This gallery shows some pictures of bad solderings - they should prevent you from making the same errors (feel free to add even more pictures here!)

From:
<https://www.midibox.org/dokuwiki/> - MIDibox

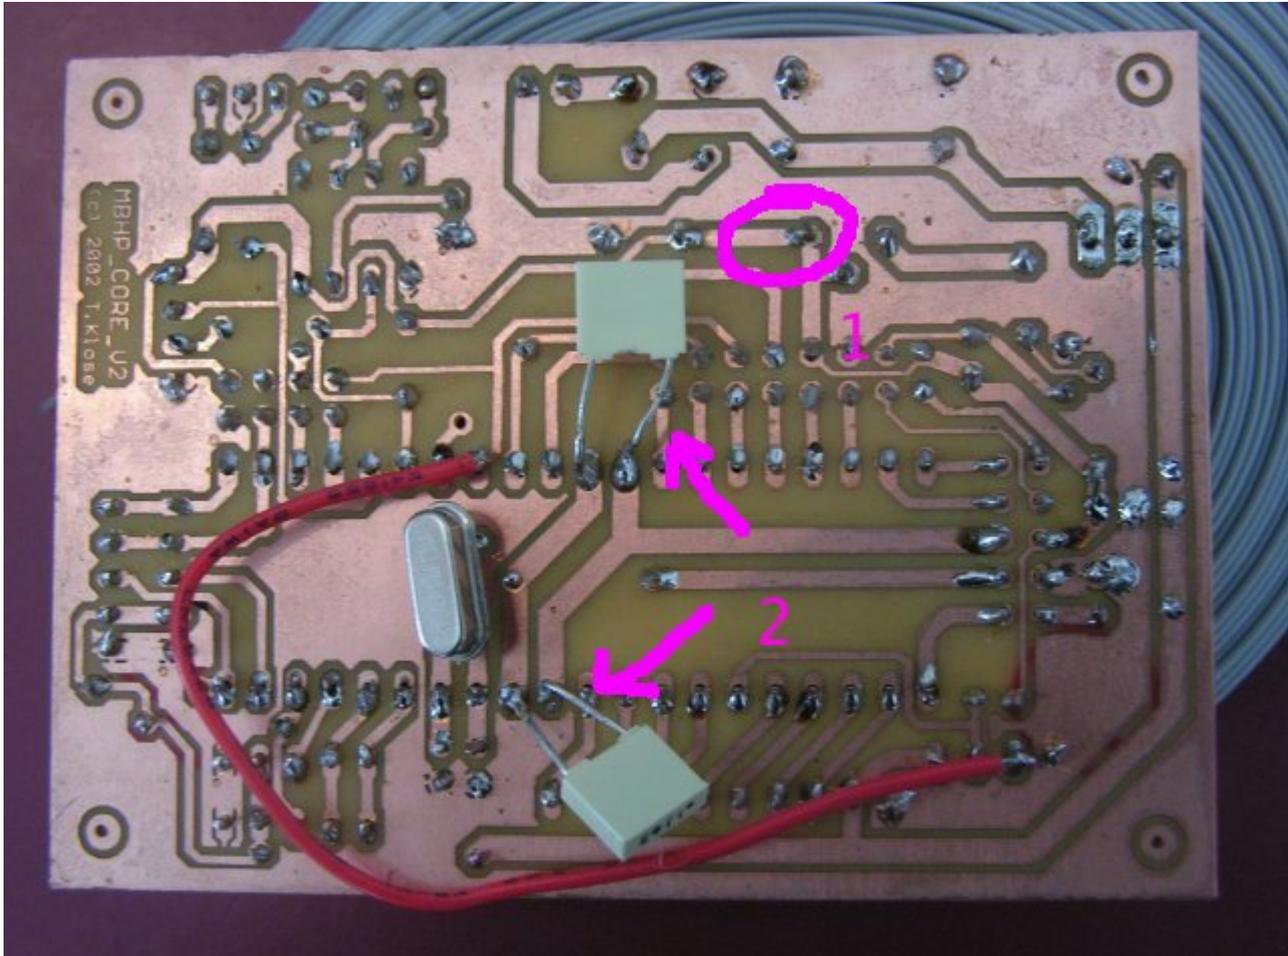
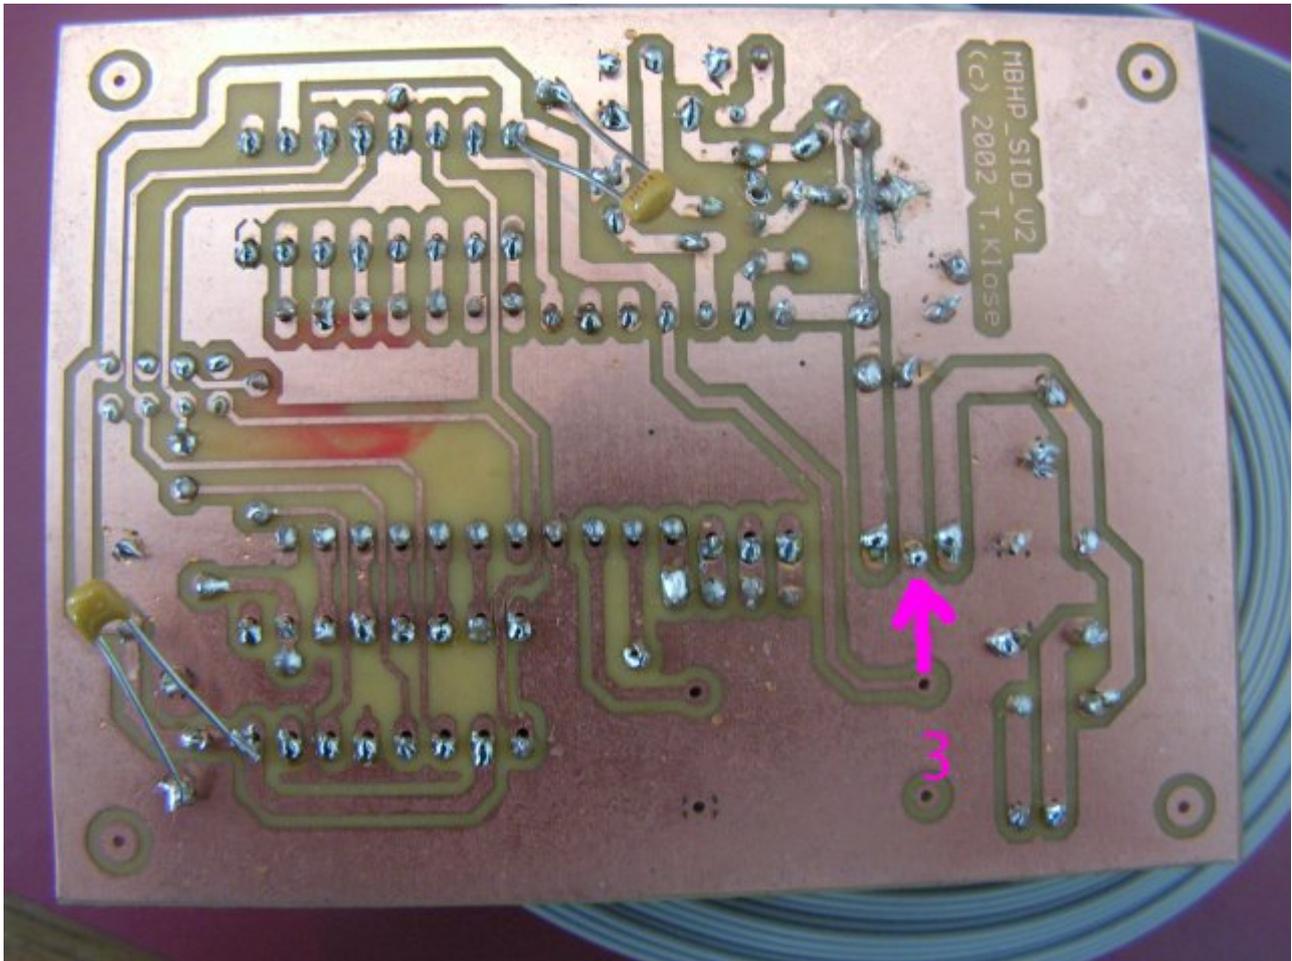
1: the core module has some bad solderings (loose connections), which could lead to failures. There are also missing solderings (e.g. 33pF cap below crystal). It makes sense to solder each pad again, the [Soldering](#) guide in the Wiki gives some useful tips

2: the legs of the caps should be cutted, otherwise they can cause a short circuit which can damage the PIC!

3: this seems to be a bad ground connection directly at the 78xx - it can lead to the wrong voltage. Here the same: just solder the pads again, it will help

And same like above: the long cap legs need to be cutted, the danger for shorts is too high!
